## **SERVICE BULLETIN    February 2011**

Inspection of Nose Gear Strut weld for possible cracks at the welds. Zenair has been made aware of the weld at the nose gear cracking on an aircraft CH2000. Zenair is recommending that all CH2000 owners inspect the weld area within the next 50 hours, following each hard landing, and annually after.

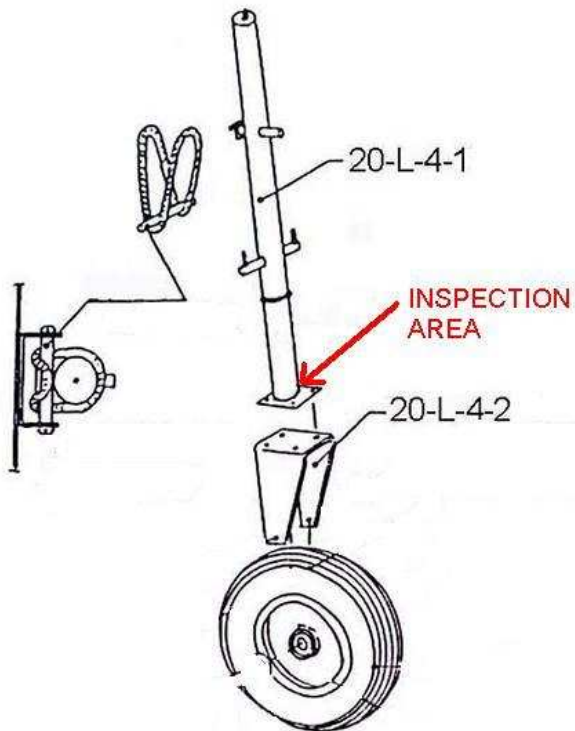
Inspect the weld area at the bottom of the nose gear strut plate. If the area is getting stressed, the plate attaching the nose wheel fork may start to bend. This is a good indication that the weld area may be cracking. If a good visible inspection confirms that there is no cracking, the inspection is complete. If one is not sure, use the following to inspect:

Inspect the weld at the bottom of the nose gear strut for cracks using the outline in FAA AC No. 43.13-1B when performing the inspection by using the Fluorescent Liquid penetrant method. There is no need to remove the nose gear strut for this test.

If any cracks are found, prior to further flight, replace the strut or repair the strut. If no cracks are found, the inspection is complete.

For re-welding of the nose gear bottom plate, do this in accordance with FAA AC No. 43.13-1A. Both the strut tube and plate are made of 4130N steel.
